# TECHNICAL BULLETIN

**MODEL/DERIVATIVE:**  
Freelander

**Bulletin N°:** 0083  
**CDS. ref:** L8715bu  
**Issue:** 1  
**Date:** 21.11.01

**PROBLEM:**  
REAR CONSOLE LID CATCH BROKEN

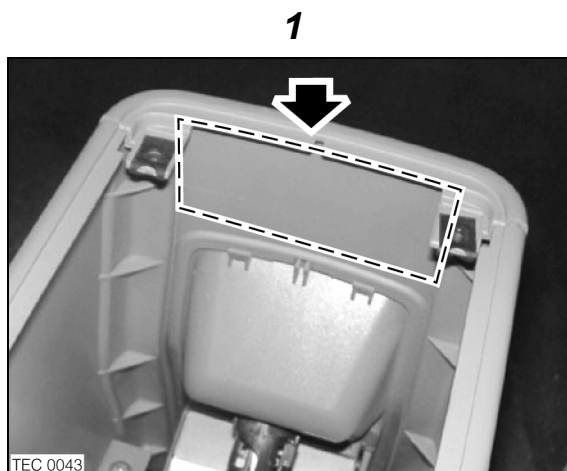
**CAUSE:**  
The rear console lid detaches from the cubby box and the catch becomes misaligned to the console. When the lid is closed in this condition the catch breaks.

Where a complaint of the above is confirmed, replace the rear console lid with a new lid, which is now available from Land Rover parts.

1. Remove the oddments tray liner from the console lid.
2. Raise the console lid and remove 4 screws securing the console lid and cubby box to the console.
3. Carefully remove the console lid and cubby box from the console.
4. Release the console lid from the cubby box.
5. Clean console rear finisher, within the dotted line area, (arrowed in illustration 1).
6. Cut rubber pad AZF100040, to fit within the dotted line, (arrowed in illustration 1), and fix to the top edge of the console finisher. The rubber pad stops the hinge from detaching.
7. Fit and secure a new console lid FJB100370LPR to the cubby box.
8. Carefully fit console lid and cubby box to the console and secure with 4 screws.
9. Fit the oddments tray liner to the console lid.
10. Check operation of the console lid.

*PARTS INFORMATION:*  
**FJB100370LPR - Console lid**  
**AZF100040 - Rubber pad**
